SUBJECT: Responds to 820405 request for addl info re pressurized thermal shock issue, including justification of time assumed for correct operator action in overcooling transient evaluations. Complete analysis by 820115.

Subject: Oconee Nuclear Station, Unit 1
Docket No. 50-269

Response to Request for
Additional Information Concerning
Pressurized Thermal Shock

Figure 1

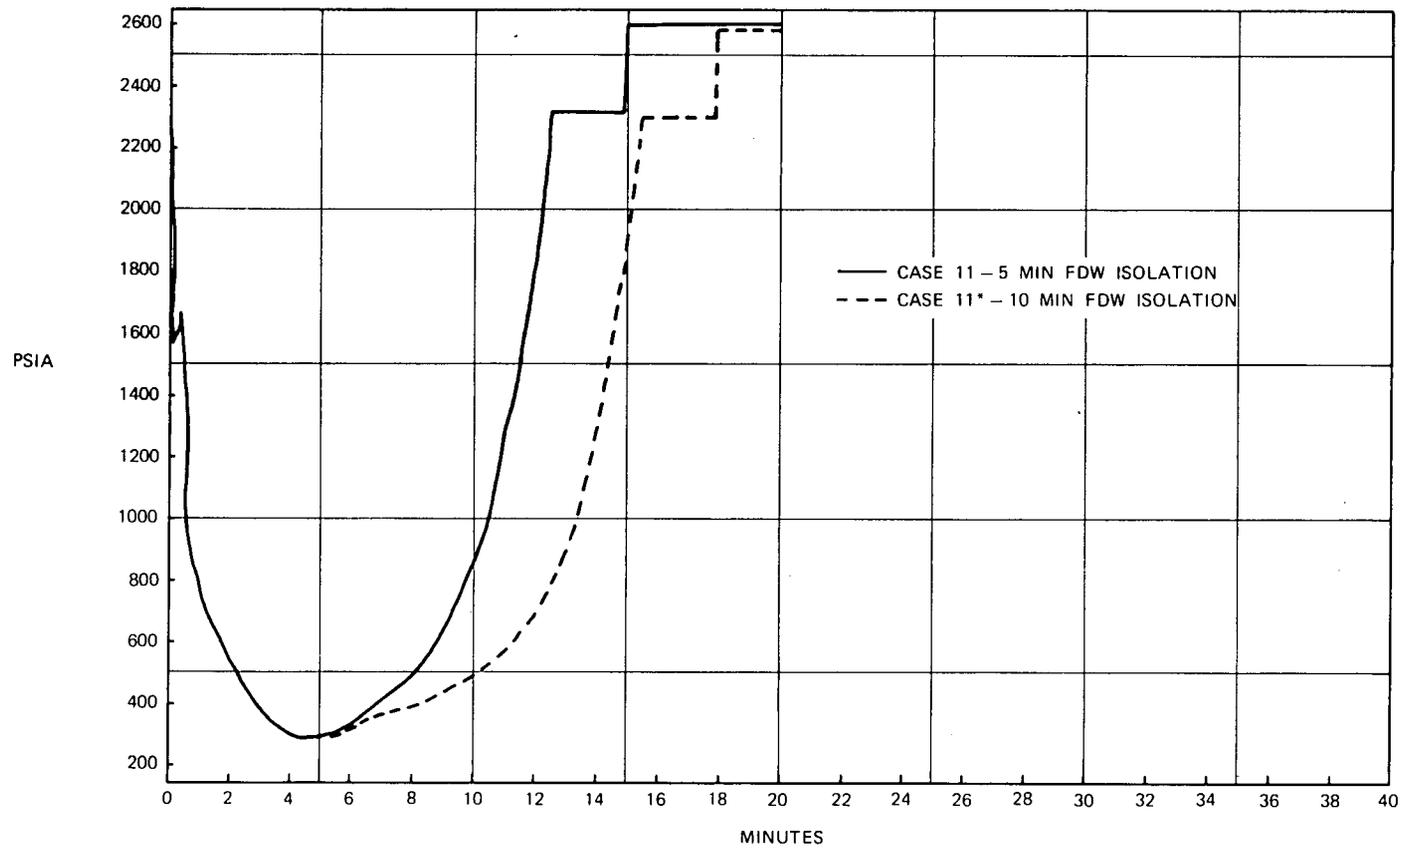
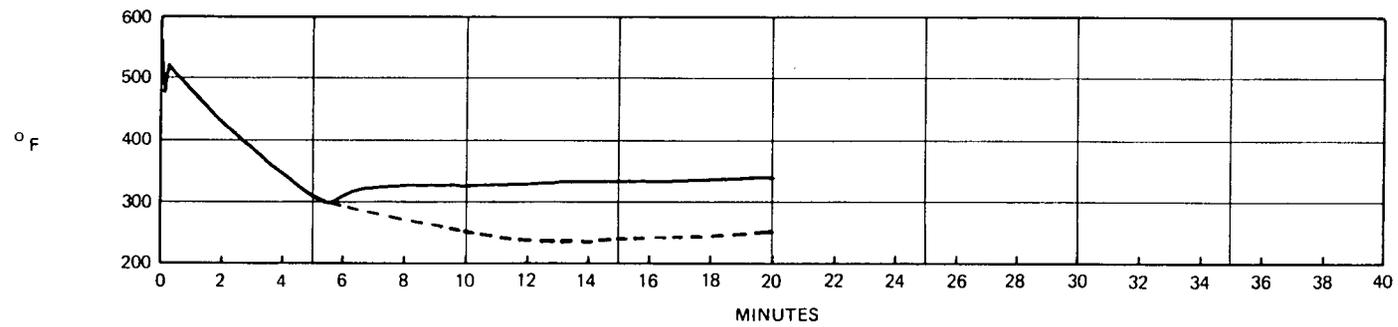
2. In the cases for the overcooling transients and steam line break analyses, provide an evaluation of the sensitivity of the transients to the time assumed for operator action (i.e., if the operator isolates the feedwater 5, 10 or 20 minutes later than assumed or restarts an RCP 10 or 20 minutes later than assumed, what are the resulting pressure/temperature transients?).

The first sensitivity simulation involves increasing the time assumed for feedwater isolation for Case 11 from 5 minutes to 10 minutes. The results of this simulation are shown in Figure 1.
